Service Bulletin No. 065

201F Fuel Pump

Valve Housing Cap Screw Replacement

Figure 1 - 201F Fuel Pump Component Identification

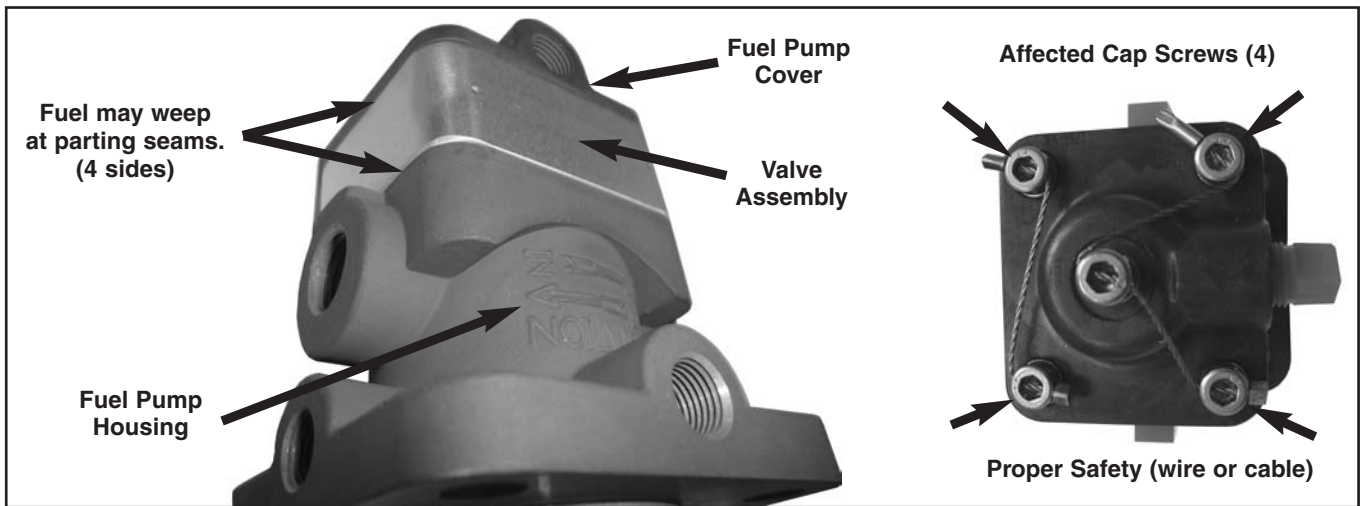
- (6) Install .032 inch stainless steel safety wire or optional Safety-T-Cable™, HET P/N RX-1961 at the head of the cap screws. Tool requirements and Installation for Safety-T-Cable™ may be found at <http://www.dmctools.com>. Refer to Fig. 1.

- (3) Using a 5/32 inch allen wrench, remove an existing cap screw, retaining the flat washer in place.
- (4) Install a new shorter P/N NAS1352C3H20 cap screw and tighten snug but do not apply torque.

- a. Repeat the removal and replacement of the remaining three cap screws one at a time, replacing each with a shorter cap screw.
- (5) Using a socket with 5/32 inch hex stock inserted and a calibrated torque wrench, torque the new cap screws in a crisscross pattern applying 23-25 in-lbs (2.59-2.82 Nm).
